**LEGAL ADVERTISEMENT
HISTORIC PRESERVATION BOARD
CITY OF PORTLAND
Public comments are taken at all meetings.**

HISTORIC PRESERVATION BOARD AGENDA

May 18, 2016, 5:00 p.m.

62 INDIA STREET

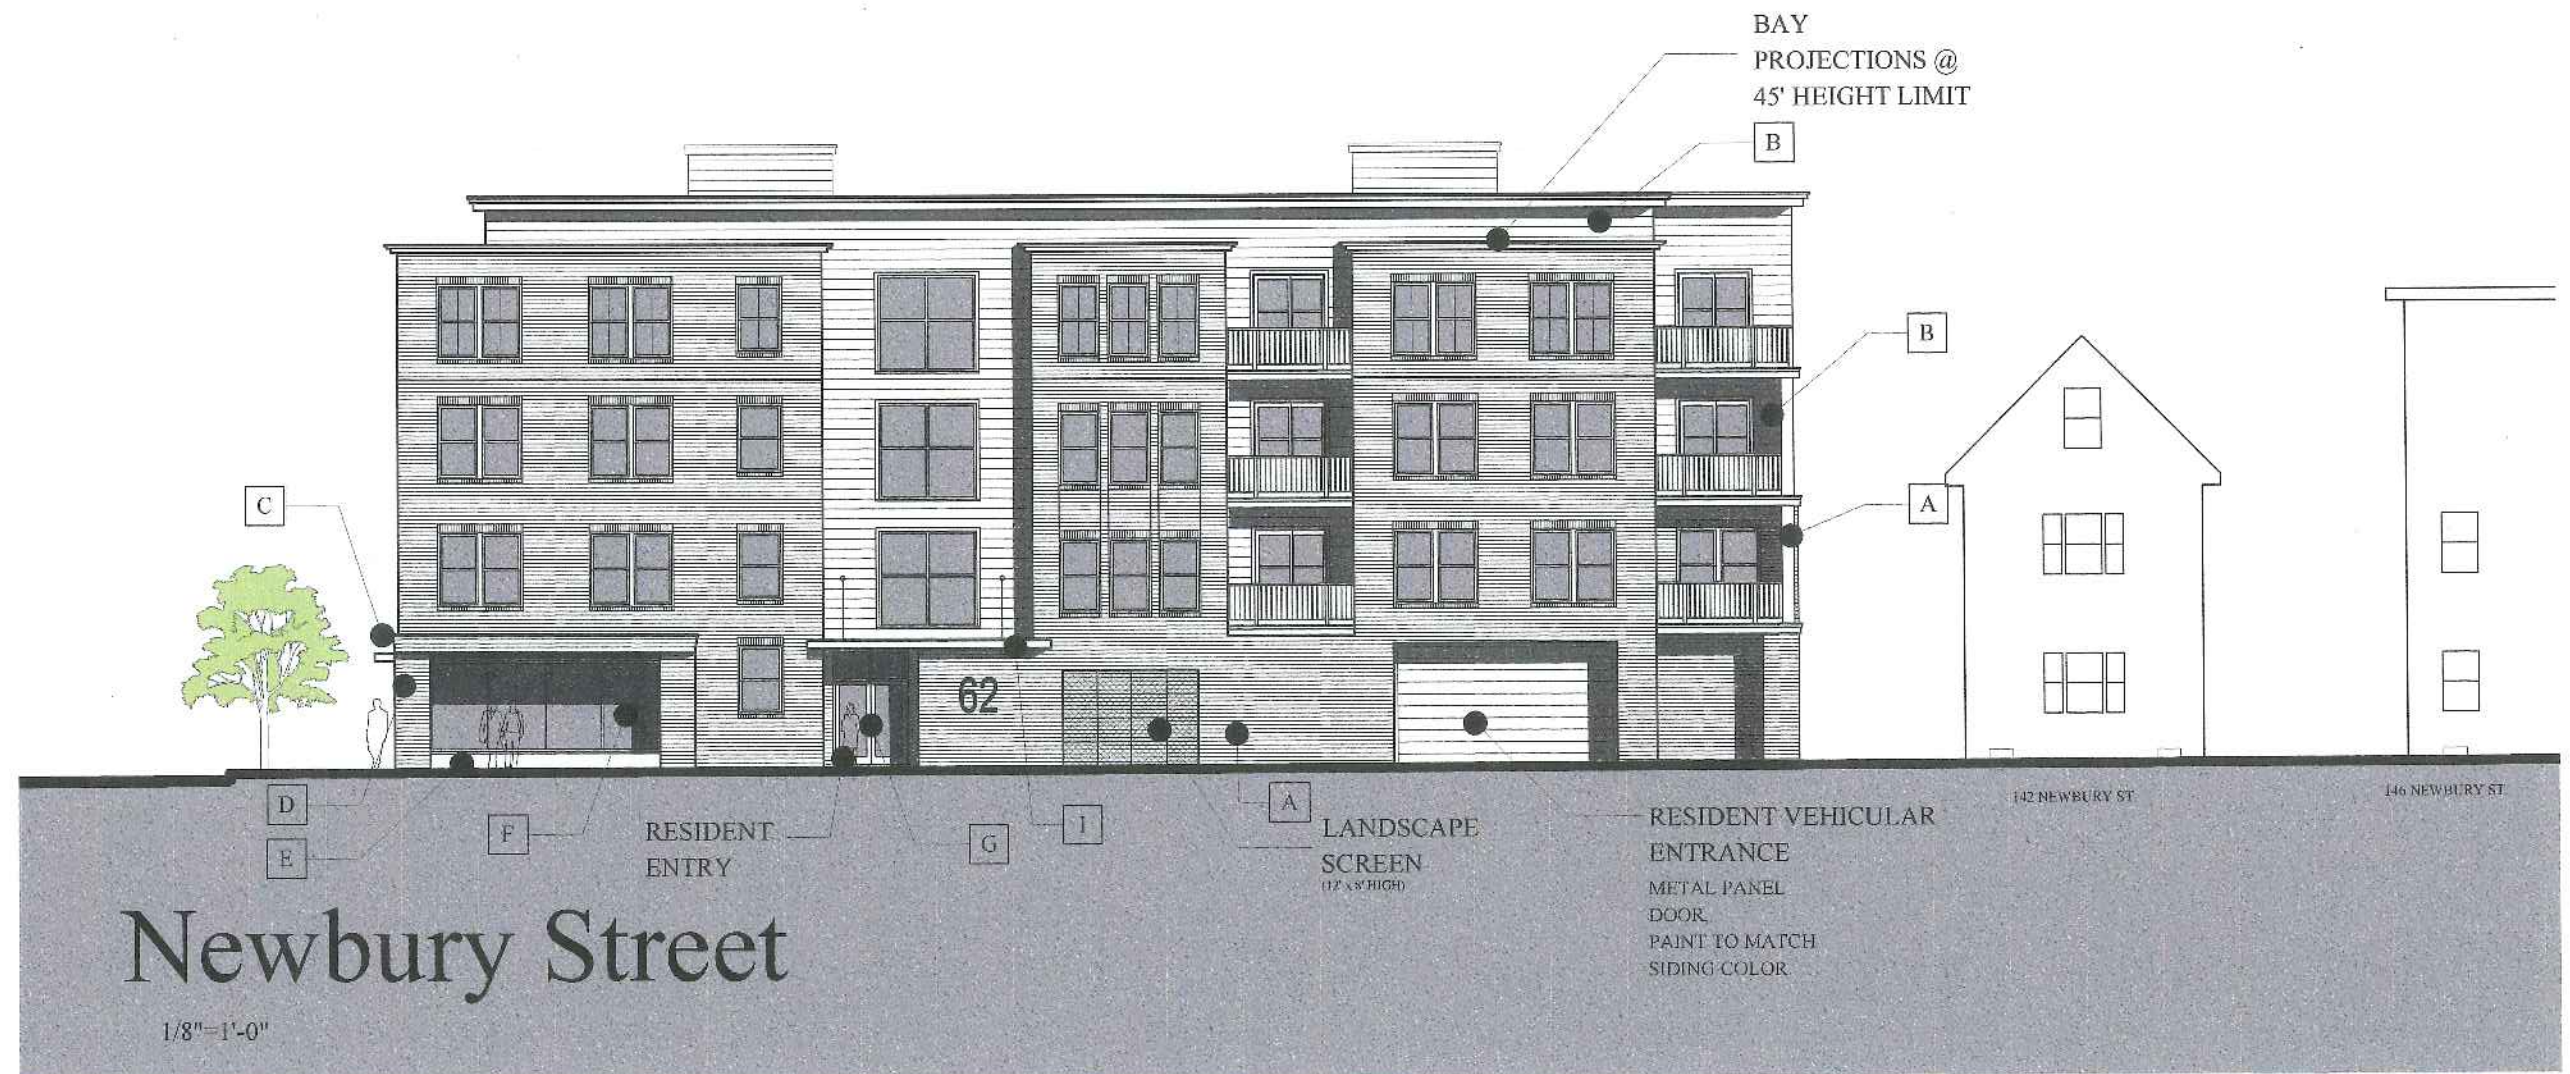
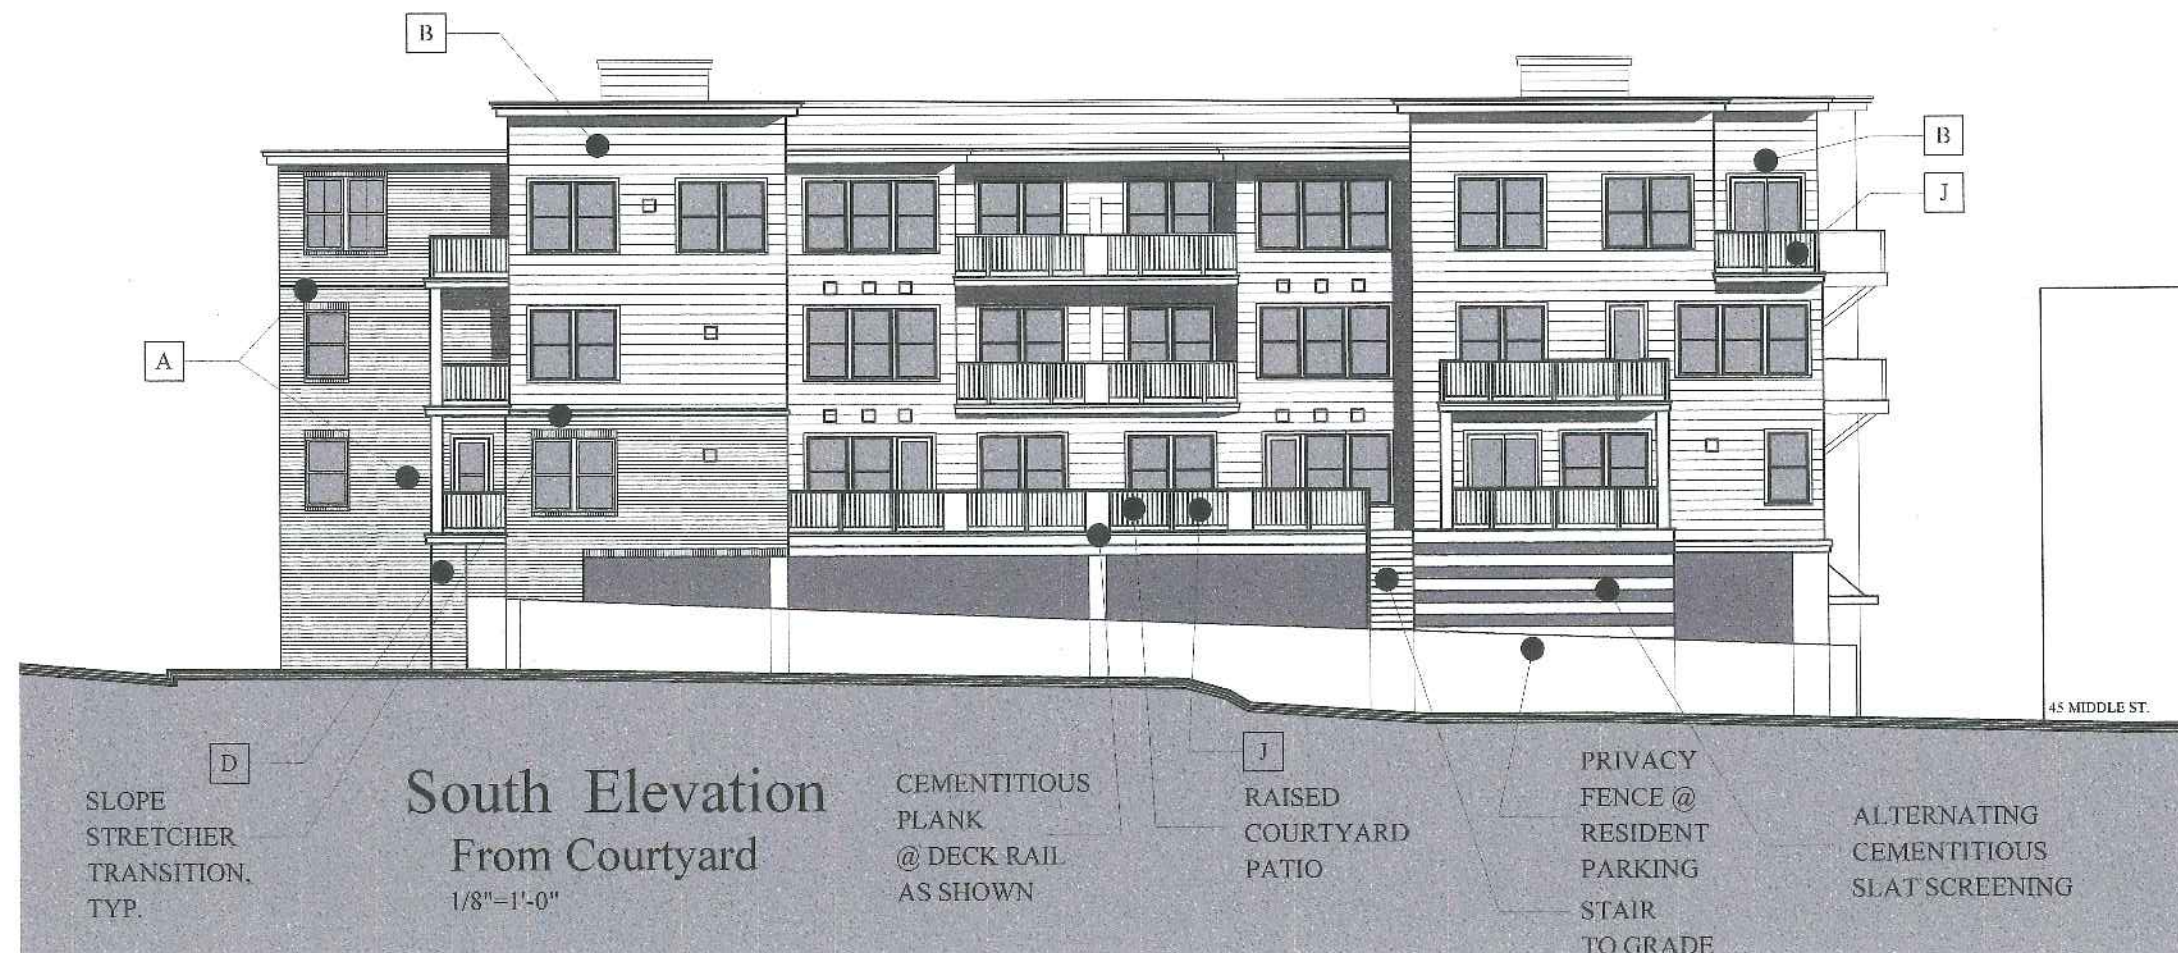
- On the India Street and Newbury Street elevations, 1/1 windows are shown at the 2nd and 3rd floor levels. 2/2 windows are shown at the 4th floor level only. Staff questions the decision to limit the use of 2/2 windows to the top floor and recommends that they be used on the lower levels as well. Staff does not have the same concerns for the two secondary elevations, which feature 1/1 windows throughout.

- At the last workshop, Board members recommended that the cementitious siding, shown with a 10" reveal, not be standard clapboard siding, but rather matchboard or tongue-and-groove to provide a more contemporary, distinctive appearance. On detail sheet A-4.2, it appears that the siding is still proposed to be clapboard. The Board might wish to discuss this detail.

- In response to the suggestion from a member of the Board, the revised design features a horizontal break between the third and fourth floor levels. This is achieved by the introduction of a 1" recess between brick courses. The Board should consider whether this 1" recess is sufficient to achieve the desired visual break.
